Univent Replacement at Farley Elementary School
Univent Replacement at Willow Grove Elementary School
MSA File No. 42052

SED No. 50-02-01-06-0-003-011
SED No. 50-02-01-06-0-030-016

Re: ADDENDUM NO. 1

Drawing Title MECHANICAL DETAILS - 3	Drawing No. FES-M-503
---	---------------------------------

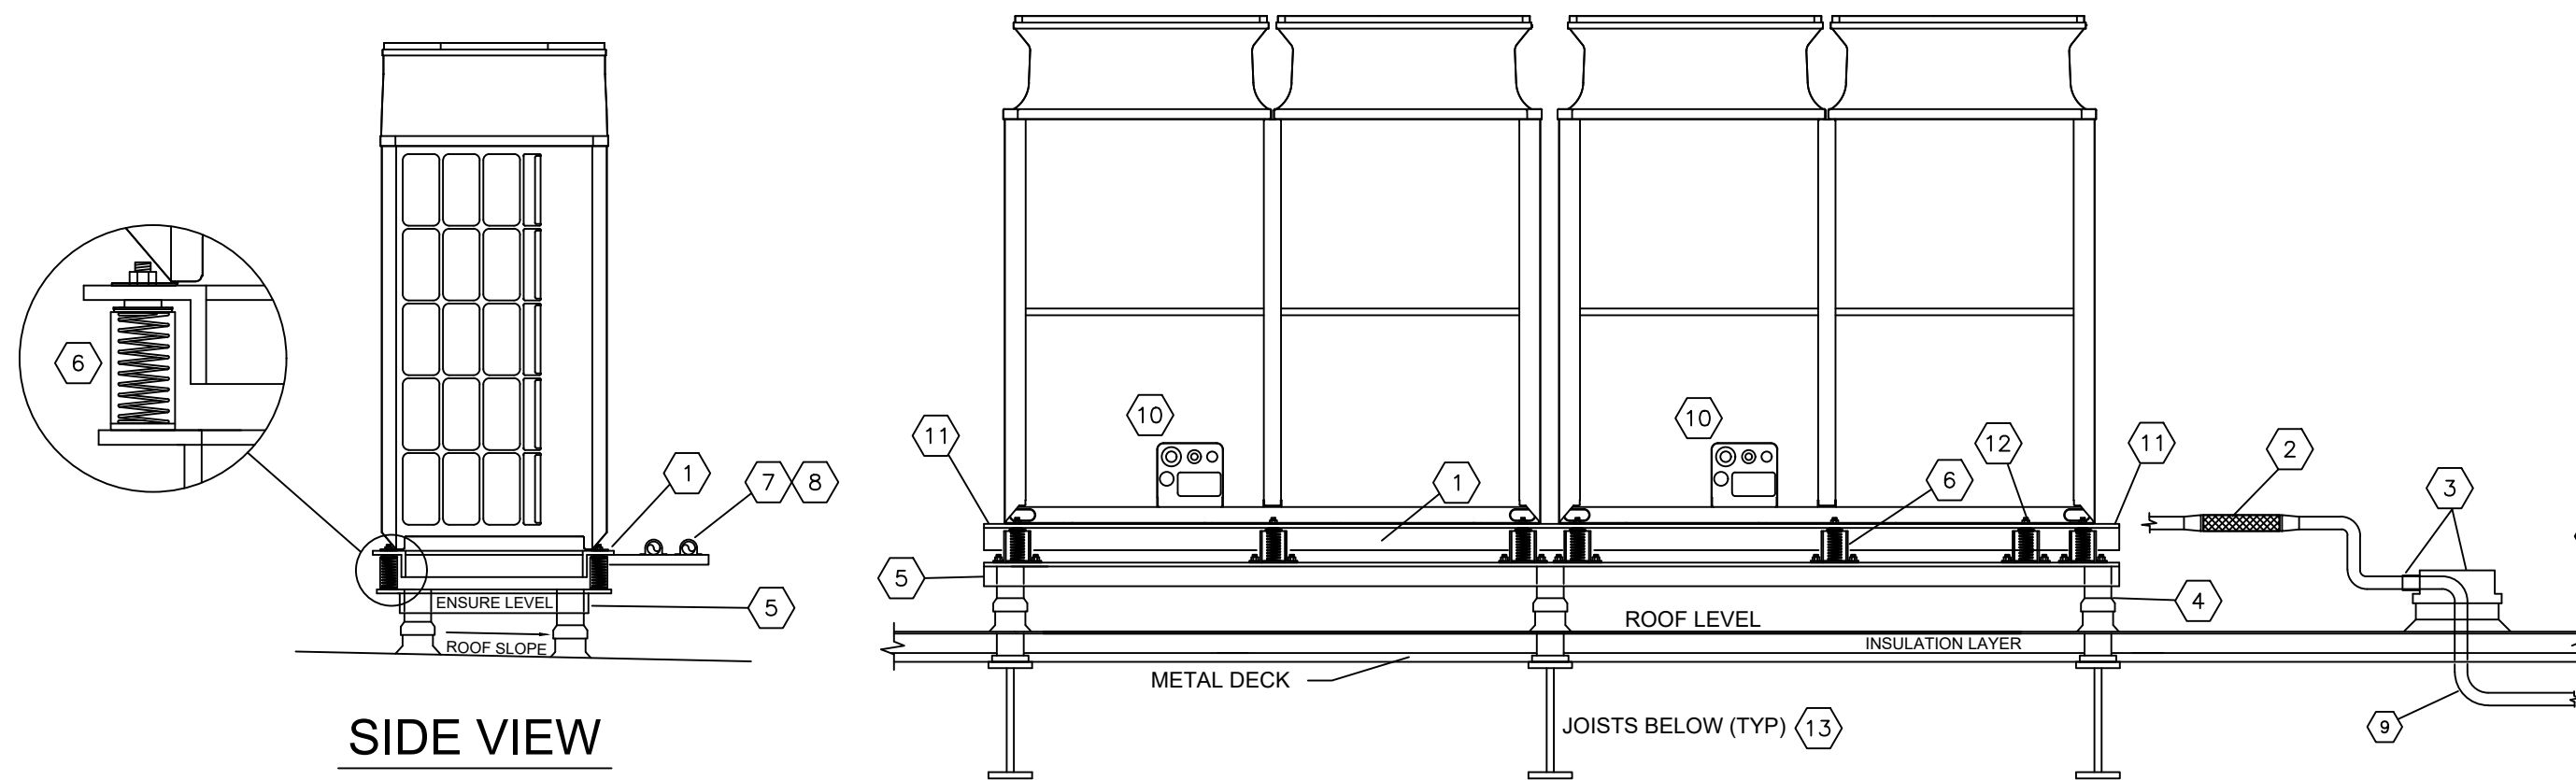
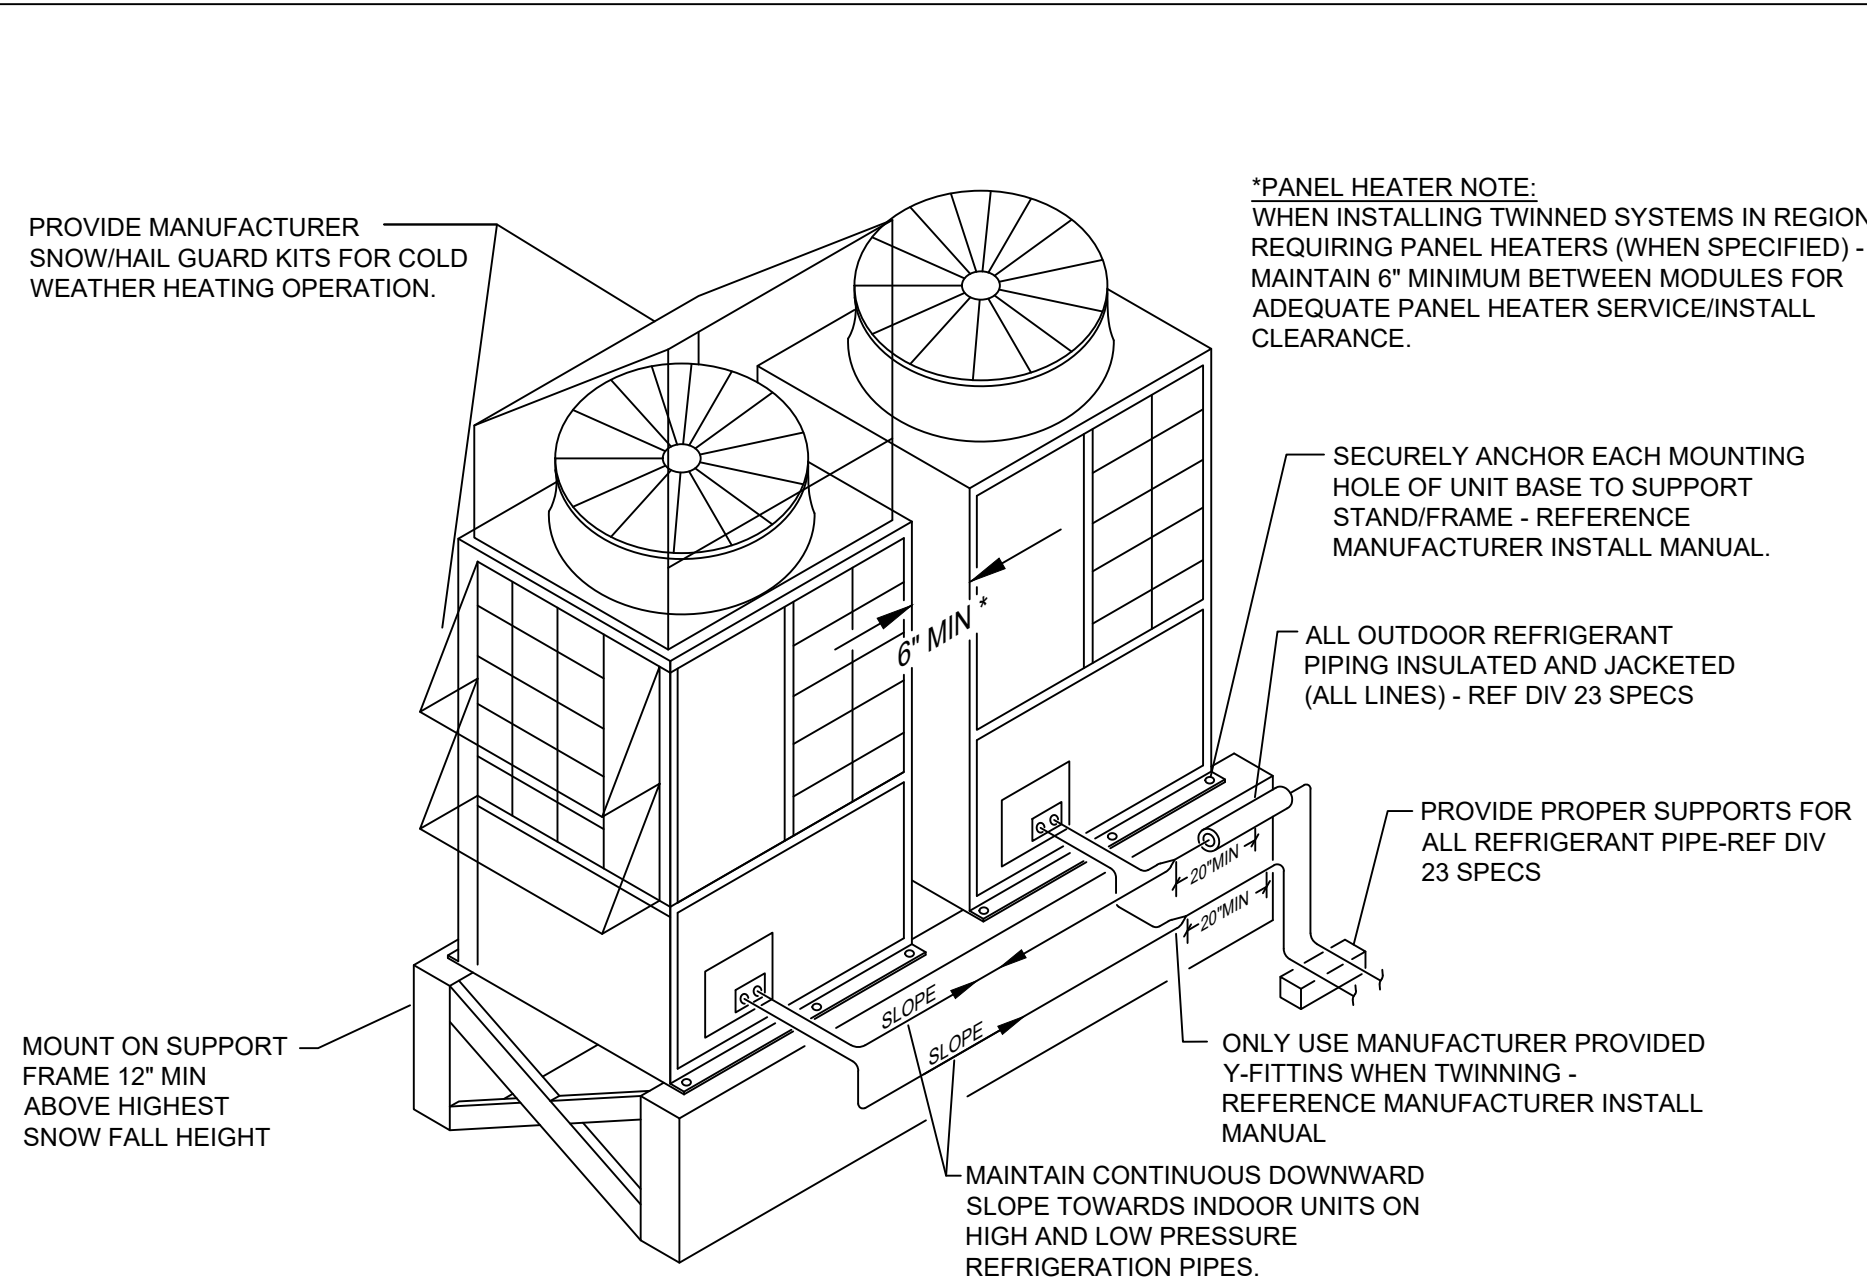
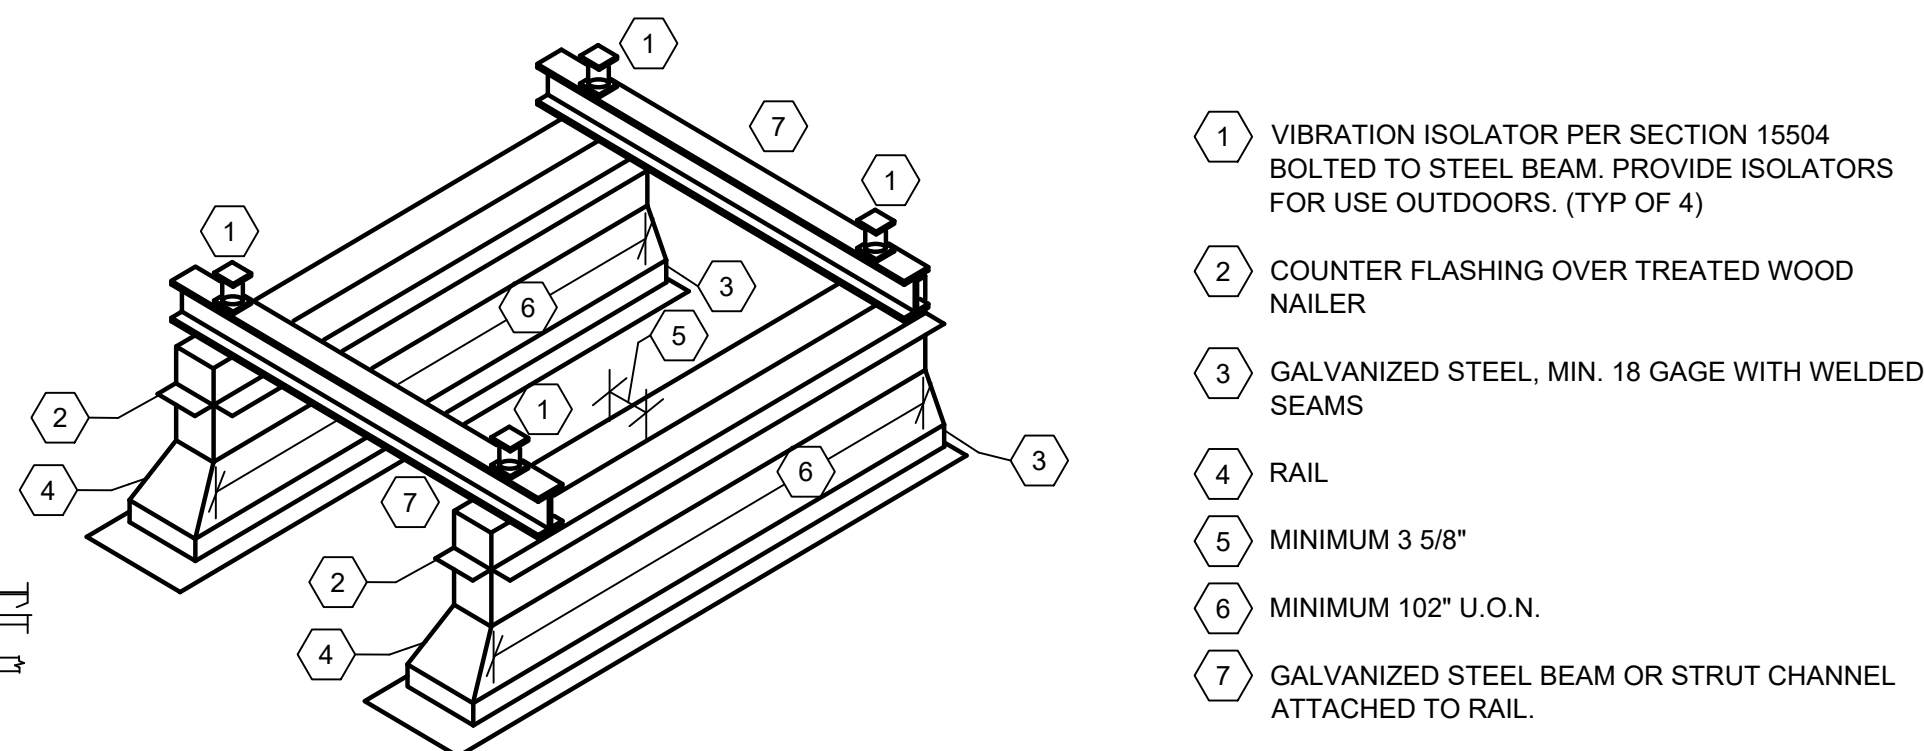
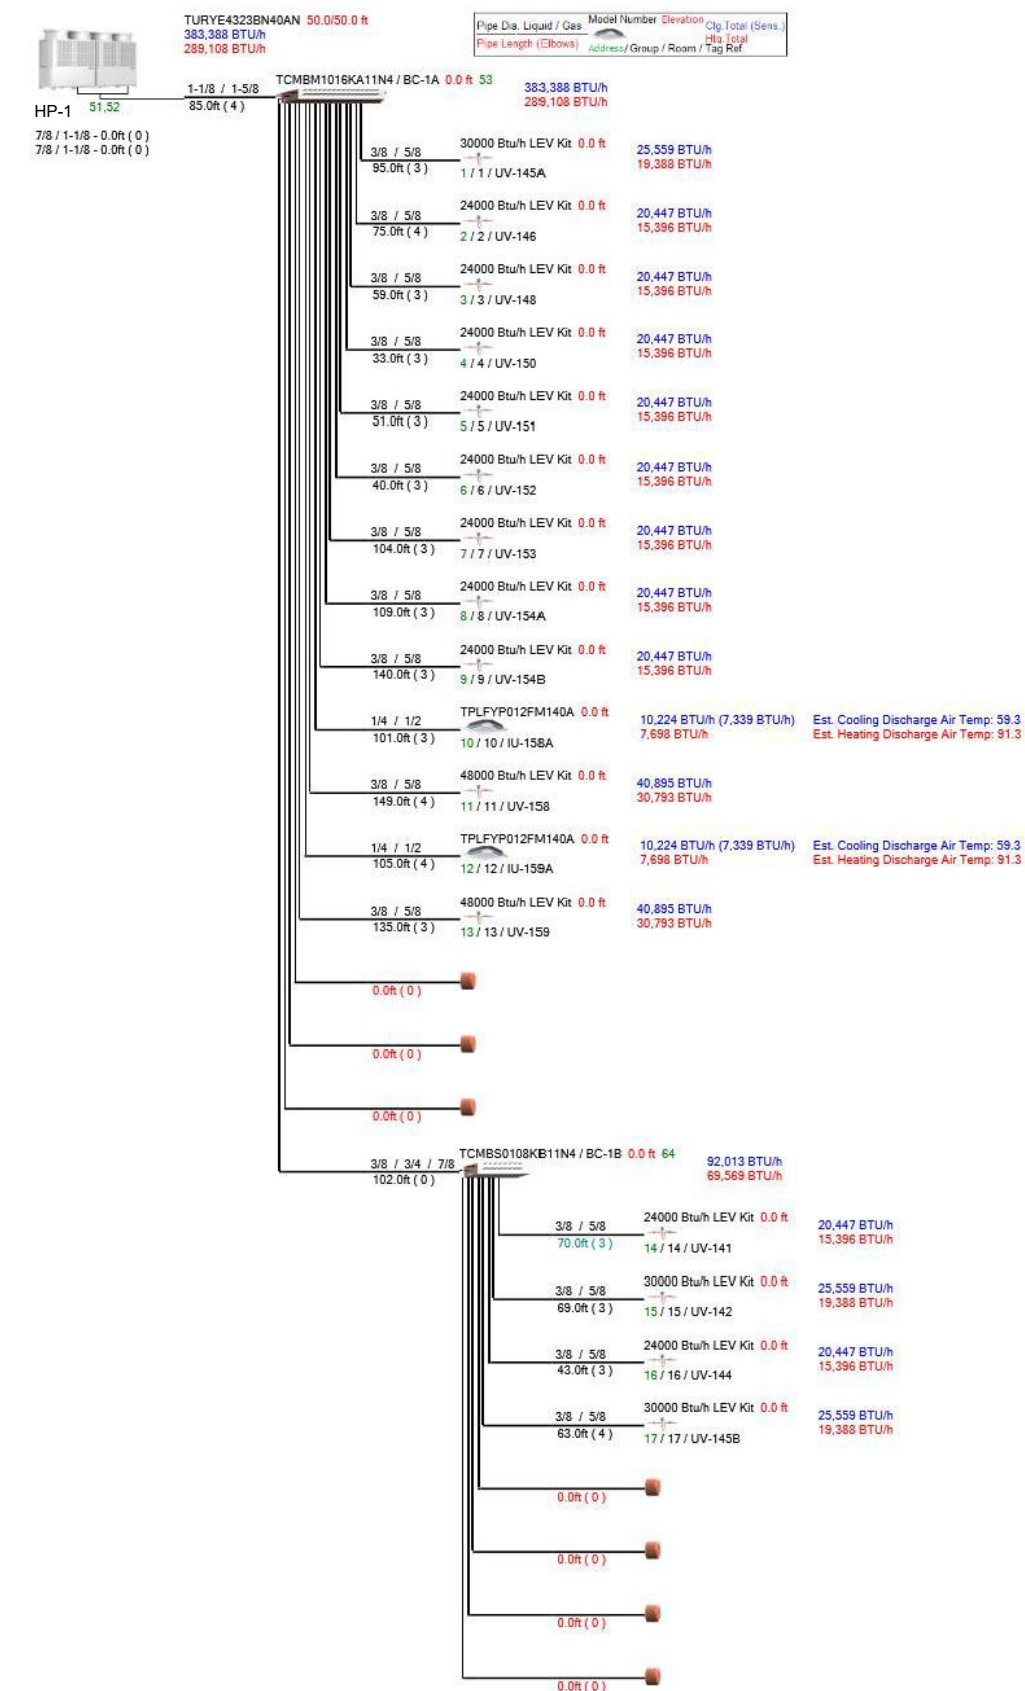
- 23) Drawing FES-M-503 has been revised, dated 11-09-23, see attached. Revisions include removing details for rooftop condensate piping support and refrigerant piping detail. See Addendum No. 1, item 22.
